HF46F Product packaging change	Versions: 2
	PMI_20200706	Page 1 / of 2

Notice on packaging changes for HF46F Family

Tube change:

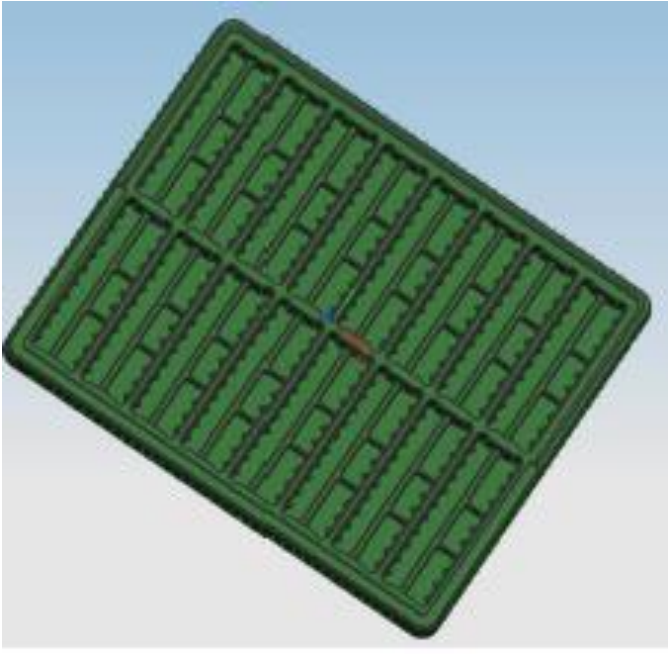
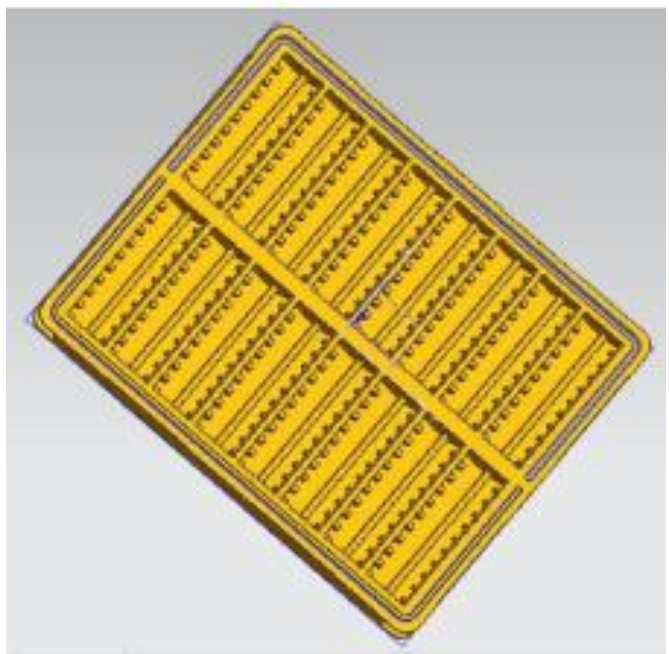
Hongfa used 2 types of tubes, the plan is it to use in future only 1 tube for the packing for HF46F. To unify tube packing and reduce tube packing type, Hongfa plans to remain 2-type tube packing type. The change has an influence to the inner structure, the length and outline dimension will not be changed

Blister changes:

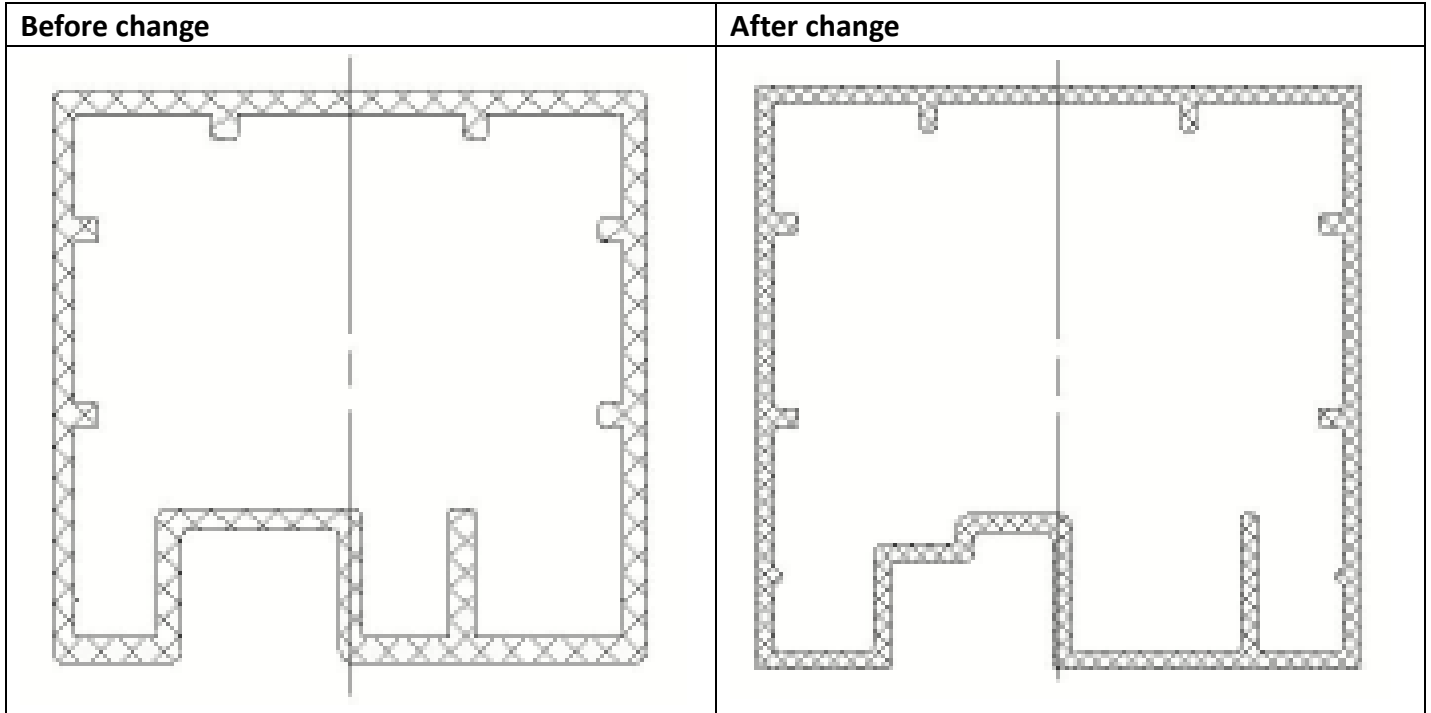
The size of the inner slots of the blister to accommodate the relay is too large and it is easy to shake the product. The relay will be now better protected in the blister, because the size of the inner groove will be reduced and the structure will be changed. The outer dimensions of the modified blister will be unchanged.
